SERVICE BULLETIN M20-275

SUBJECT: ELECTRICAL SYSTEM MODIFICATION, ADDITION TO FUSES TO CHARGING SYSTEM CIRCUIT.

MODELS/S/N

AFFECTED: M20M - S/N 27-0001 THRU 27-0279
M20R - S/N 29-0001 THRU 29-0199
M20S - S/N 30-0001 THRU 30-0039

FIGURE SB M20-275- 1

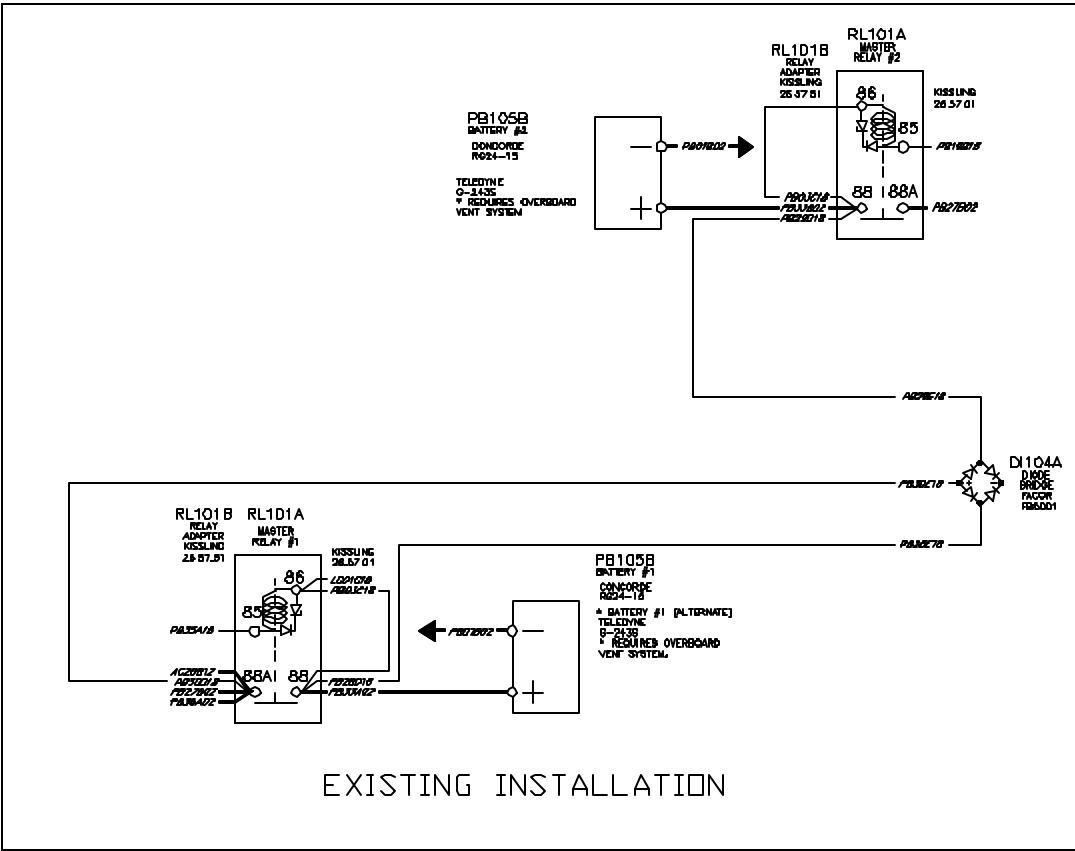
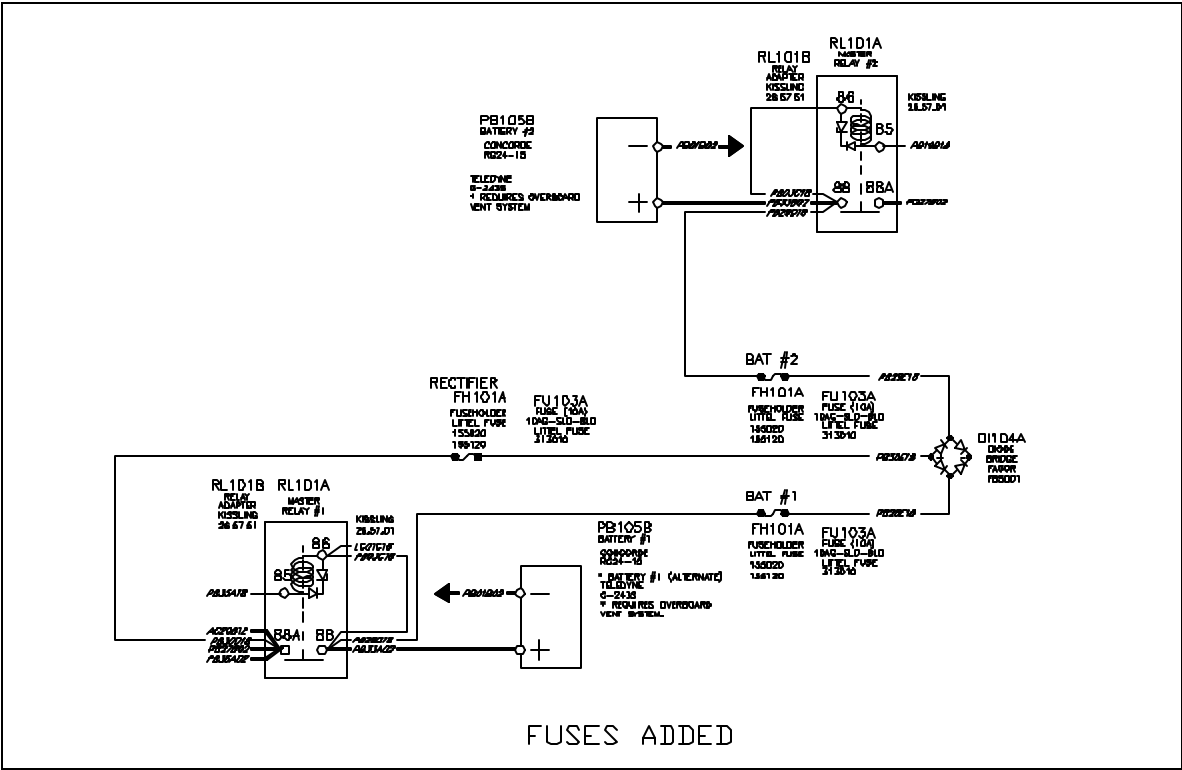
INTRODUCTION: Under certain conditions, the battery intended to get the trickle charge may not charge correctly due to current passing through the diode in an opposite direction. This may be caused by a "spike" load damaging the diode.

1. Remove forward, left hand, tailcone access door.
2. Reference Figure SB M20-275-1 for existing wiring configuration without fuses included.
3. Modify existing wiring configuration by splicing in three fuses within six inches of relay in accordance with schematic as shown in Figure SB M20-275-2.

FIGURE SB M20-275- 3

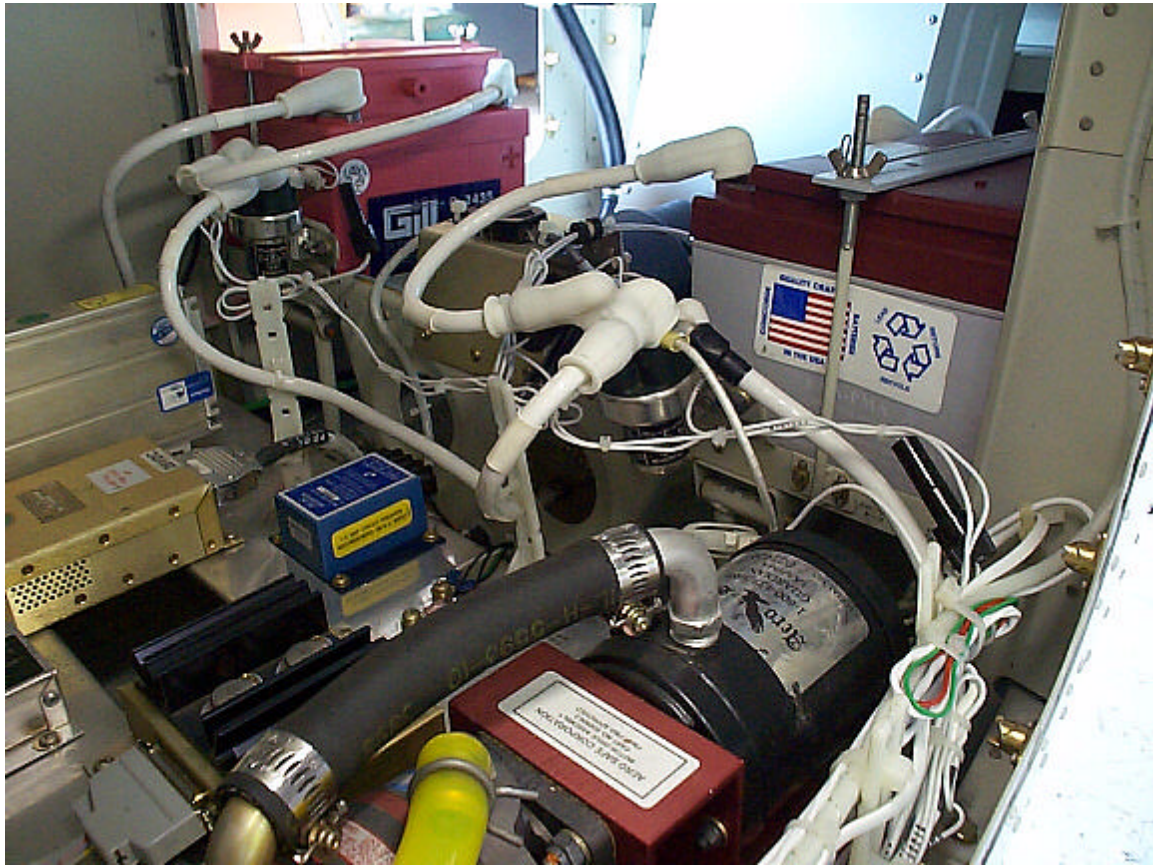
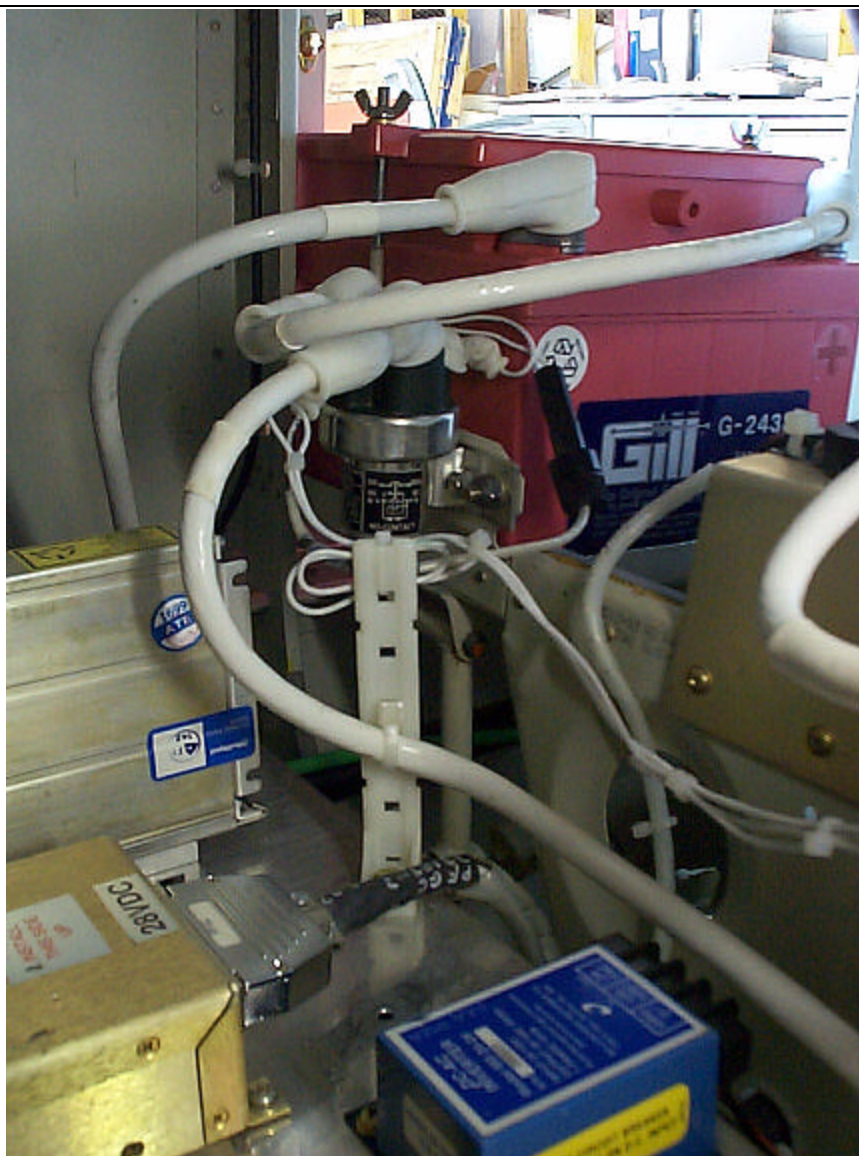
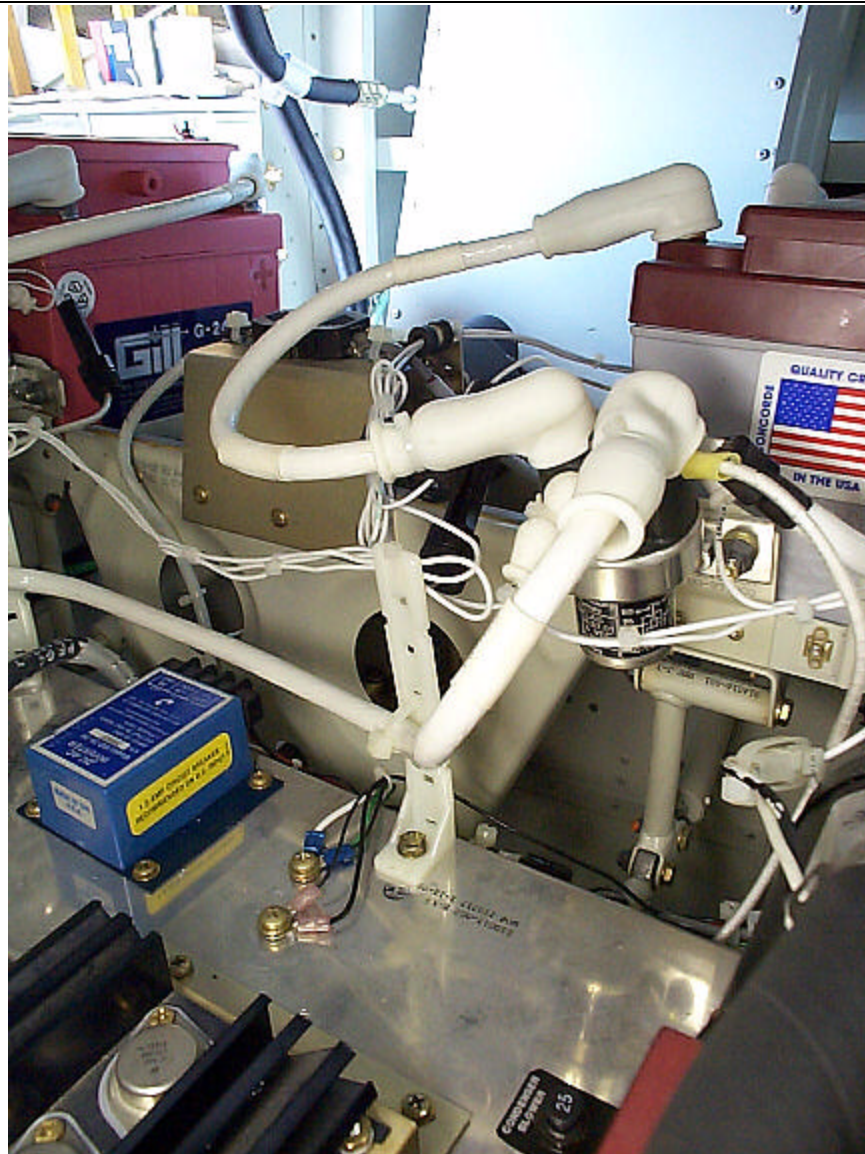
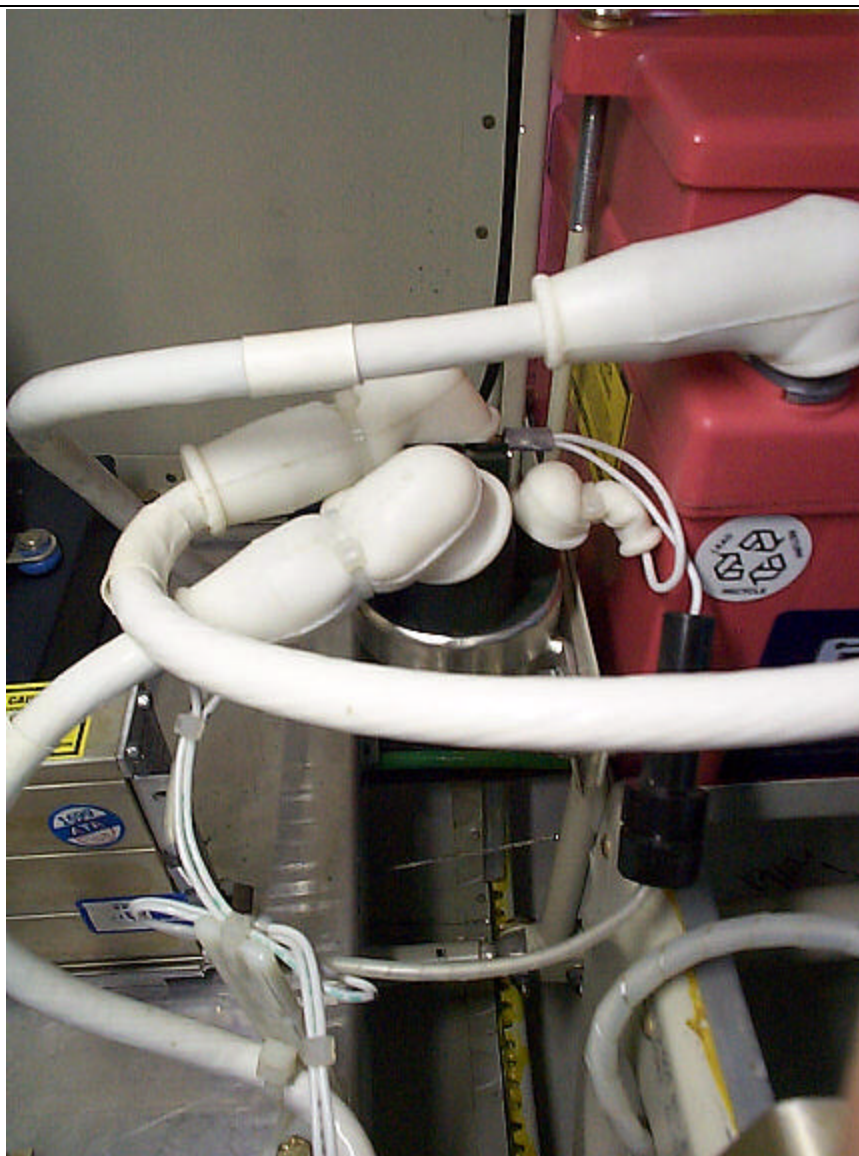
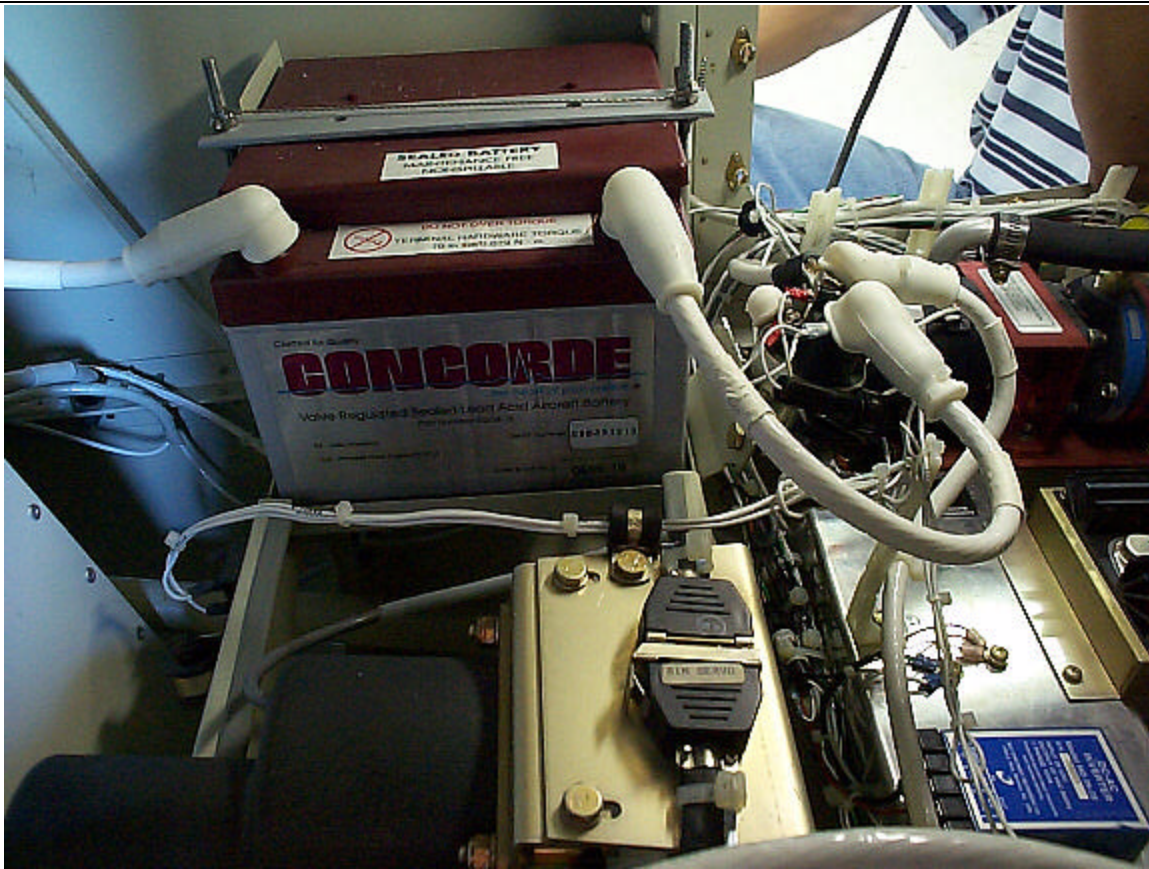
4. Reference Information Graphics Figures SB M20-275-3 through -7 for visual references and information as needed to accomplish the modification.
5. Perform electrical functional check on the trickle charging system by:
